Perry Nuclear Power Plant  
Docket No. 50-440  
Submission of Core Operating Limits Report

TITLE: CORE OPERATING LIMITS REPORT FOR THE PERRY NUCLEAR POWER PLANT UNIT 1  
CYCLE 10 (RELOAD 9)

PDB - F0001 /Rev. 10 MPL: J11 EFFECTIVE DATE: 5-21-03

SUMMARY OF LAST CHANGE: This incorporates the core thermal limits for  
Cycle 10.

Figure 3.2.1-2

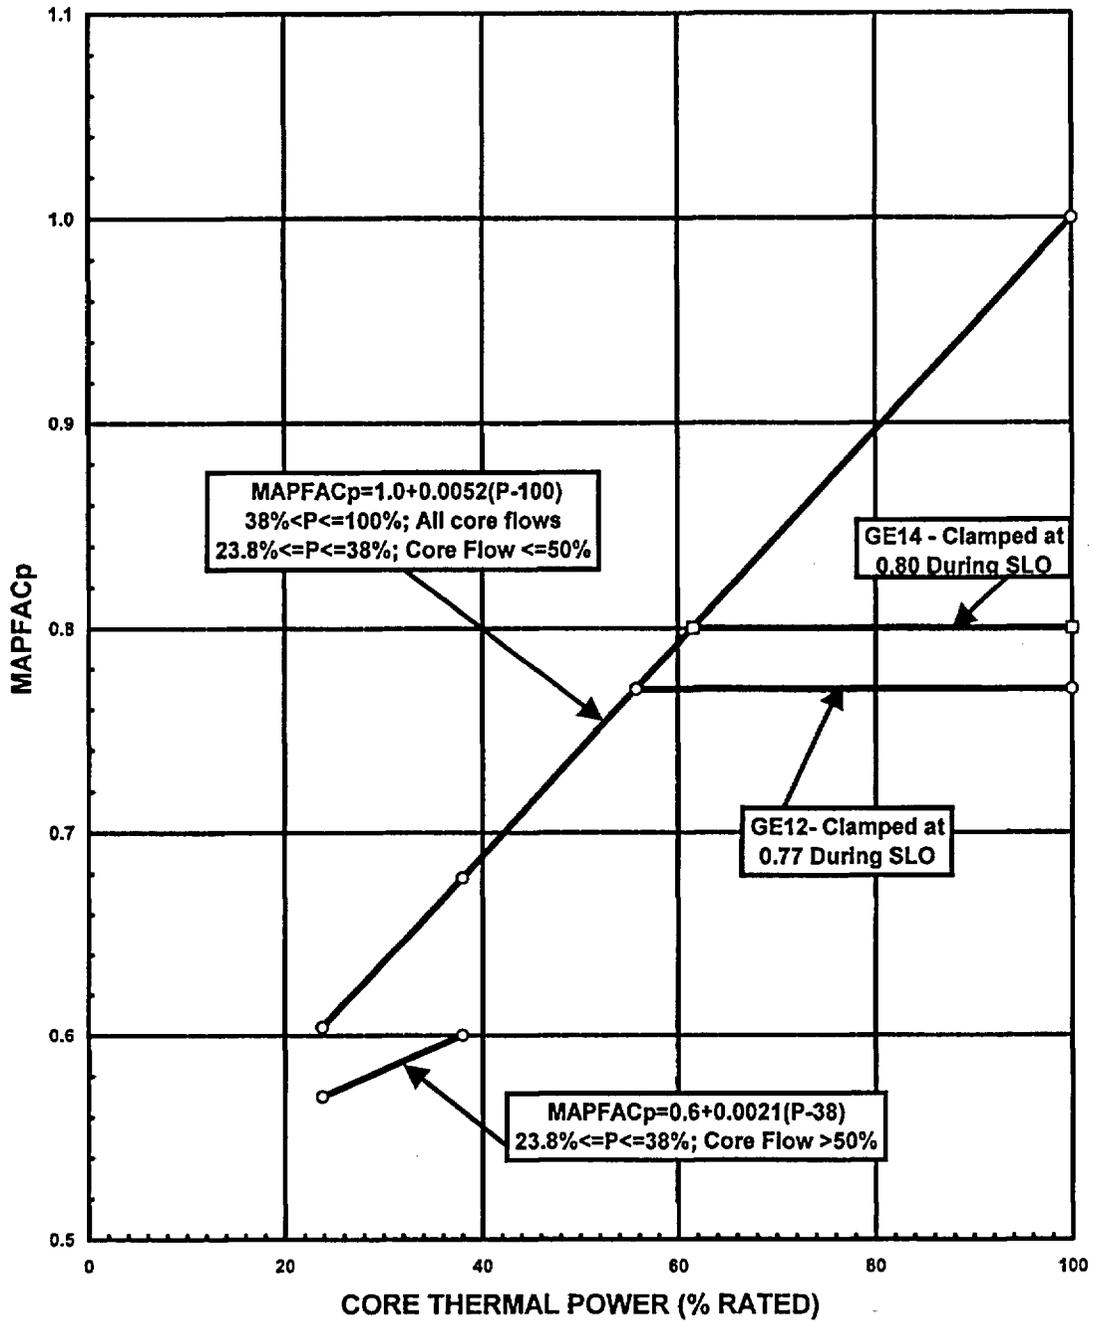
Rev. 10 - The Y-axis label on Figure 3.2.1-2 of the Perry Unit 1 Cycle 10  
COLR is being corrected to read "MAPFAC<sub>p</sub>". Figure 3.2.1-2 is the Power  
Dependent MAPLHGR Factor (MAPFAC<sub>p</sub>), Fuel Types GE12 and GE14.
